SUPPLEMENTAL INSTRUCTION

PROJ.: **Boys and Girls Club Prince of Wales**
PROJ. No.: **1716**
DATE: **July 11, 2018**
S.I. No. **S.I. - 035**

Revised block wall and low parapet at Grid K

Information Bulletin S07

TITLE: SECTION R1-REVISED (REF: S301)

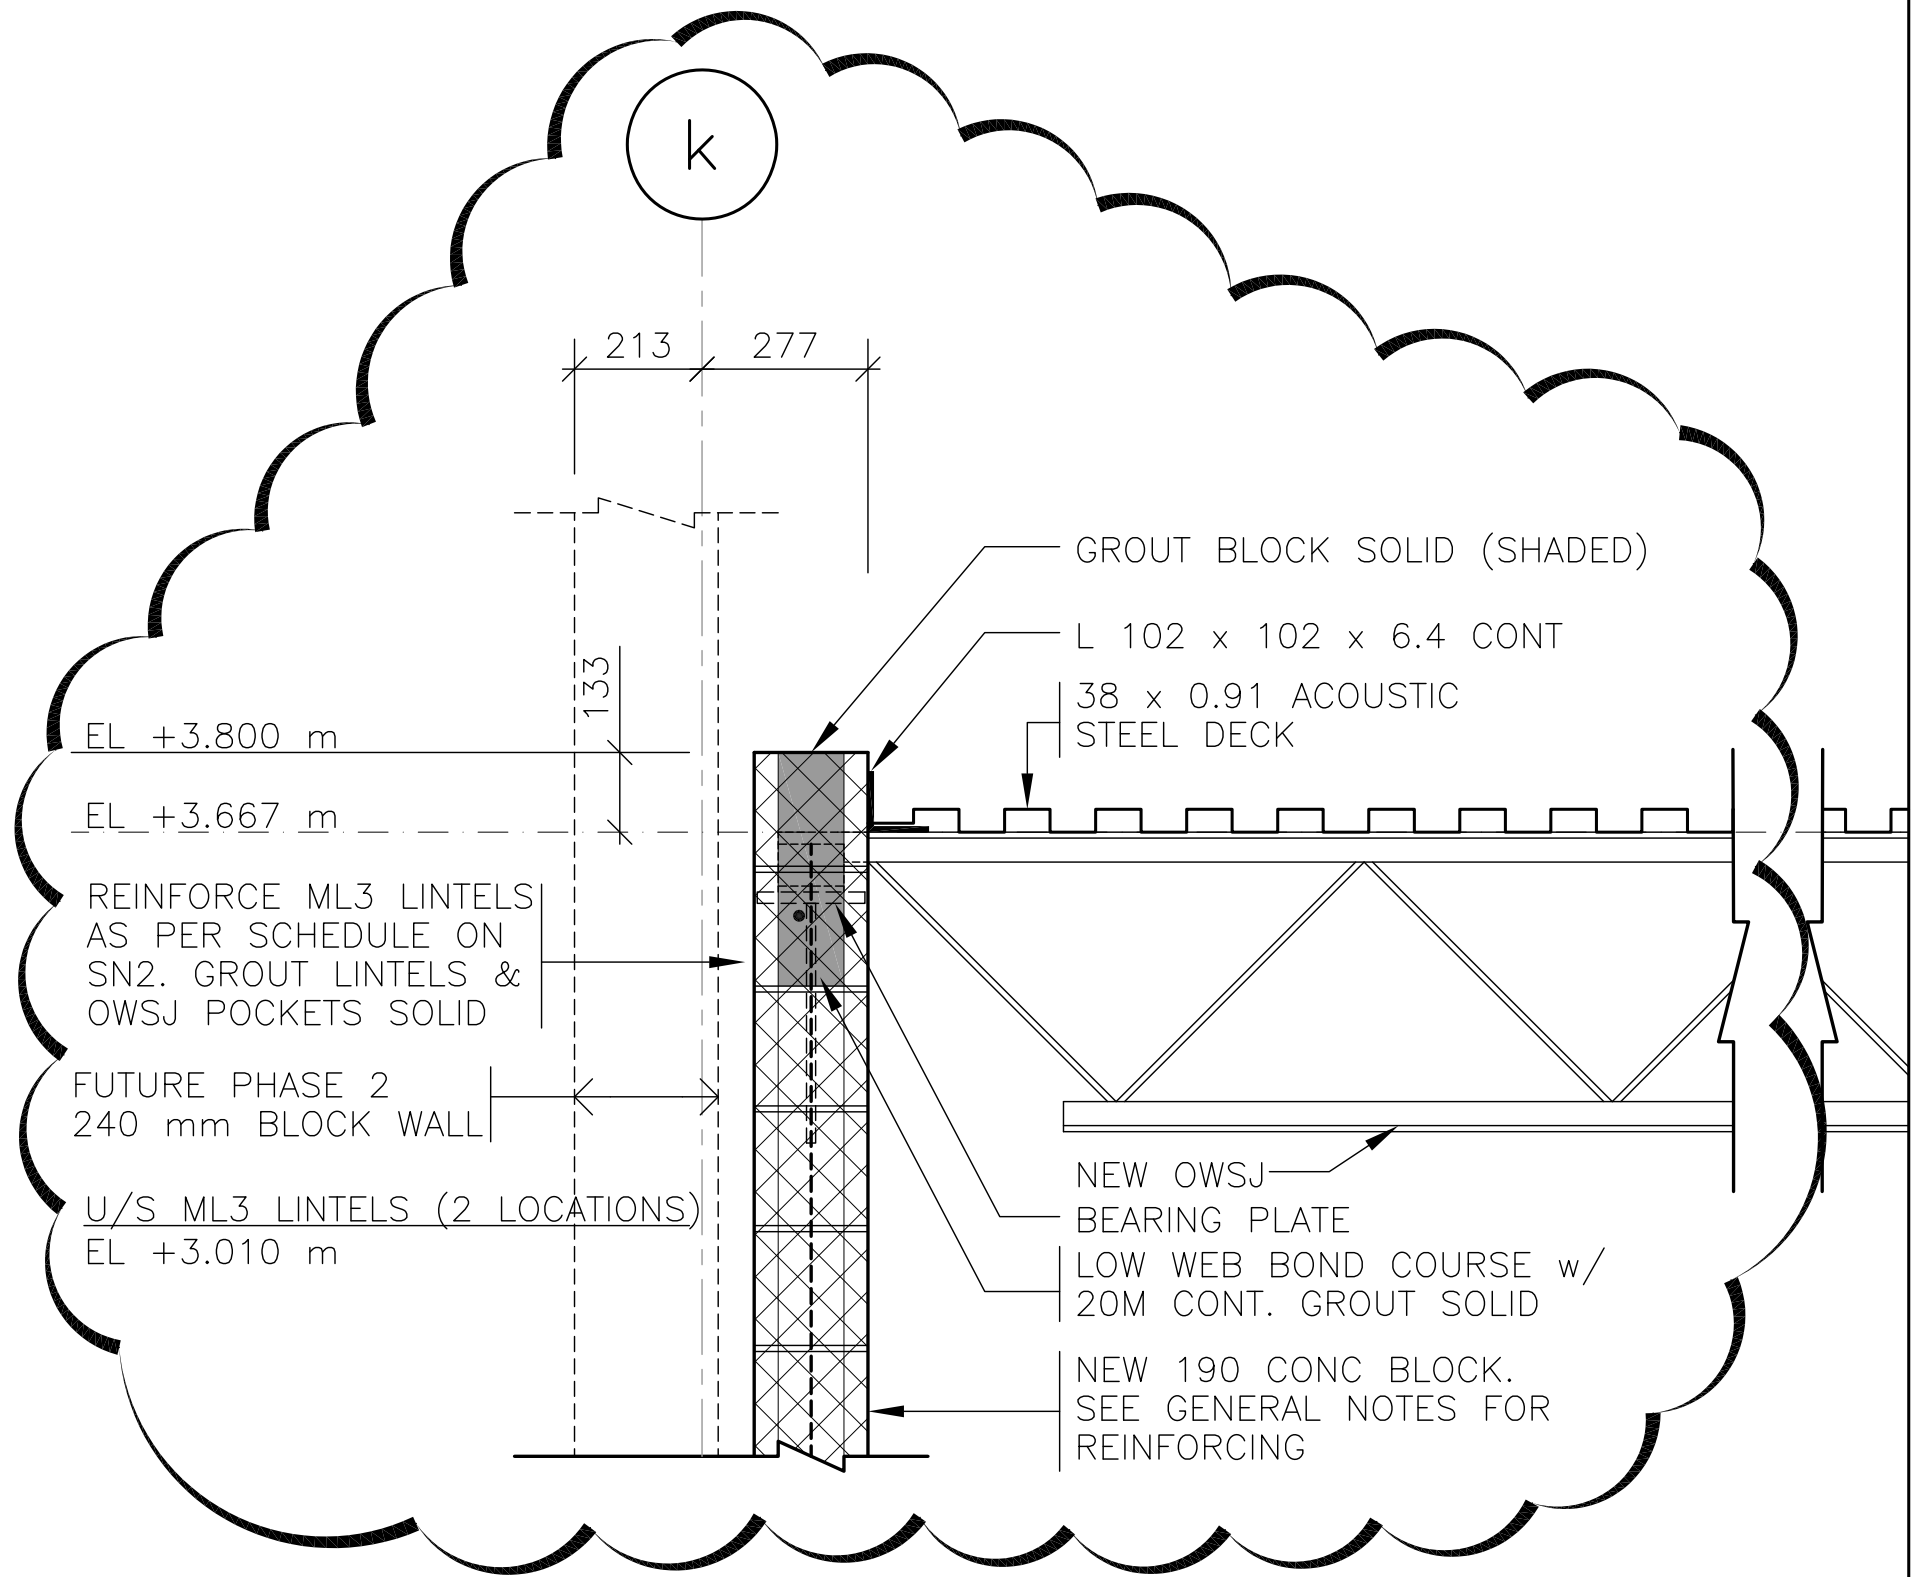
.1 IB-S07-SK9 (REVISIONS ARE CLOUDED)

.1 SK9 – SECTION R1-REVISED (REF: S301)

To correct the lintel depth related to the height of the interior window and door openings at Grid K between the games room and gym.

REVISED 11/A5.01 - LOW PARAPET AT GRID K

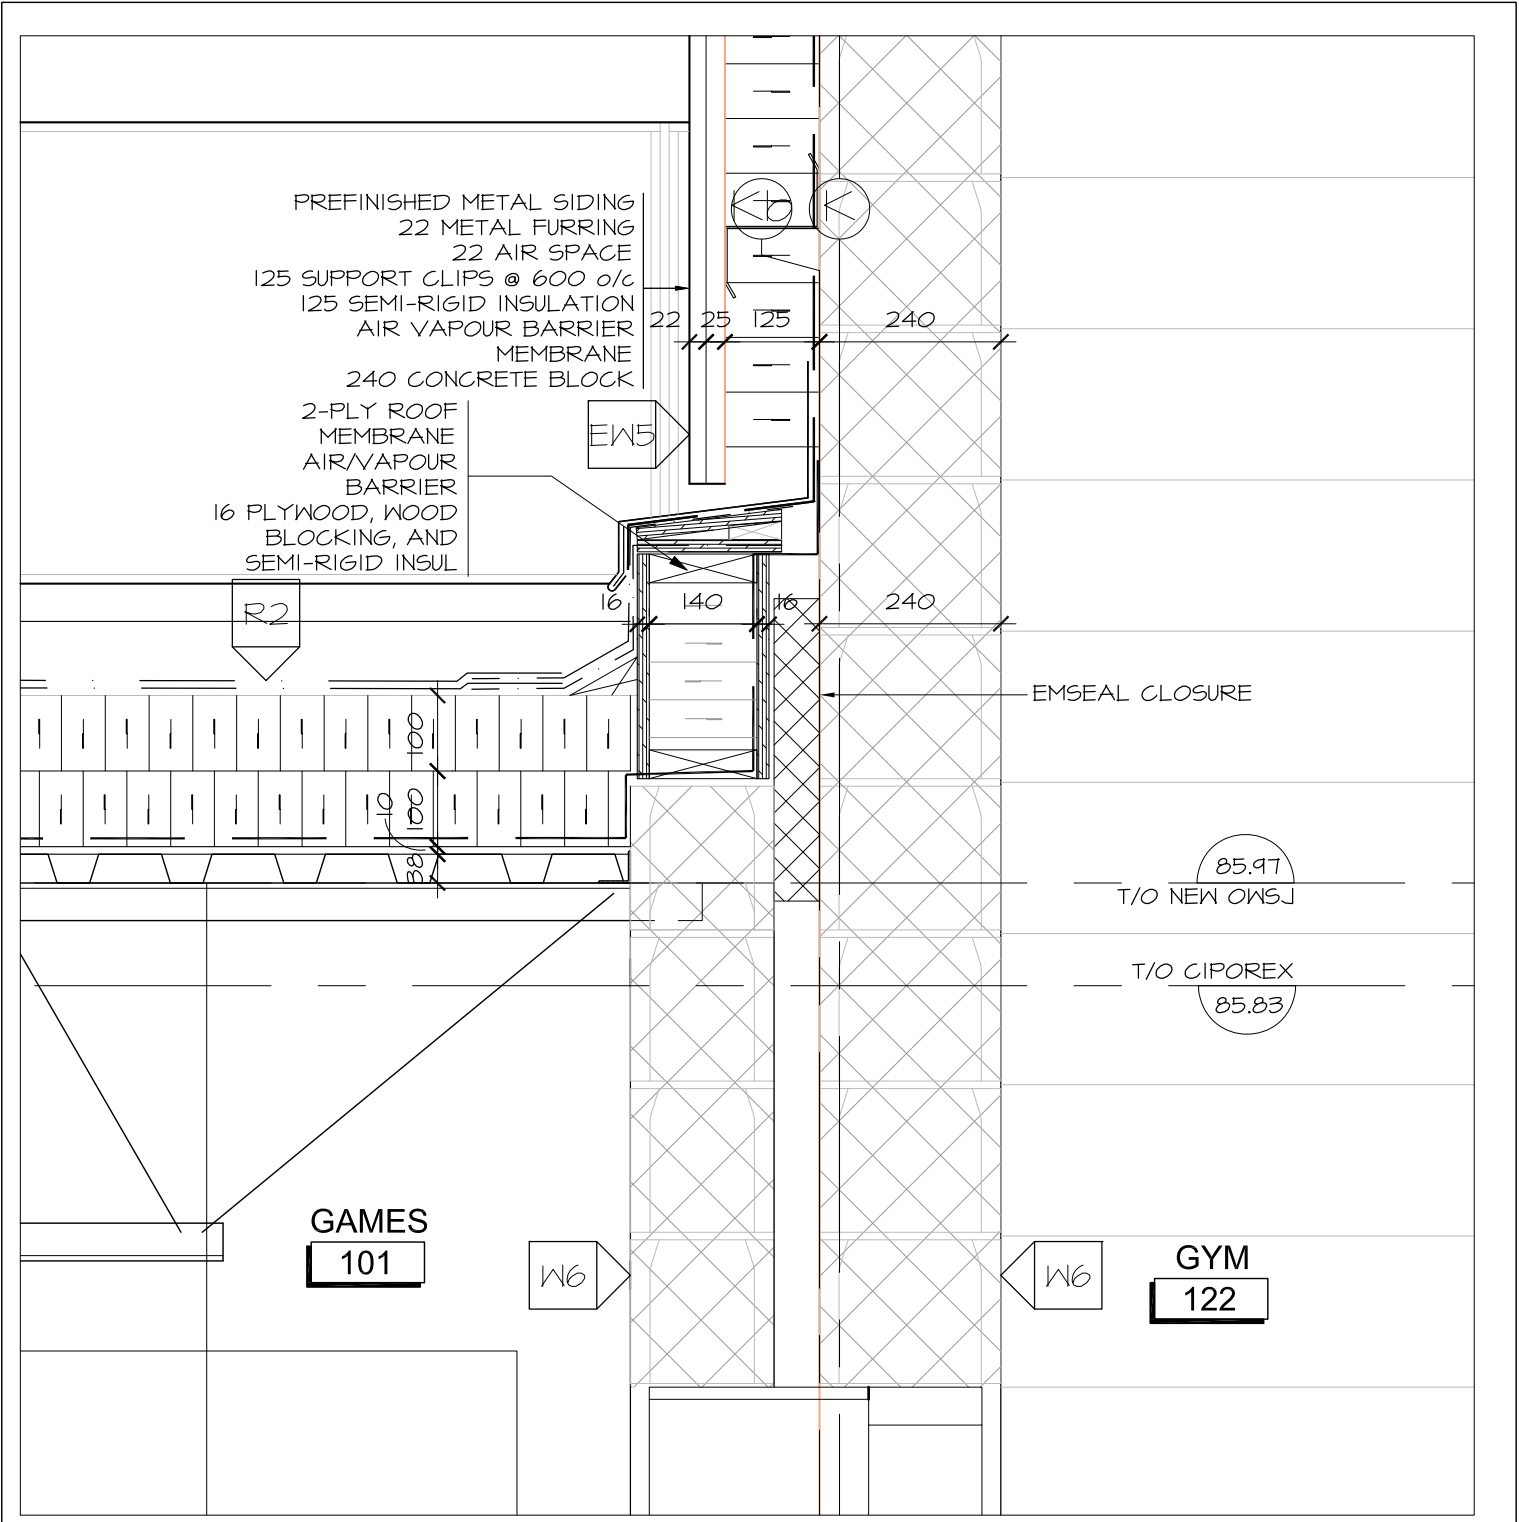
Revised low parapet at Grid K.

Architectural drawing A5.01, detail 11.

.1 Refer to attached ASK-011 for a revised version of detail of the low parapet Grid K. This change is in response to structural IB-S007.

Coordination with revised structural IB in response to a revised lintel designed required by the height of the window and door openings between the games room and gym.
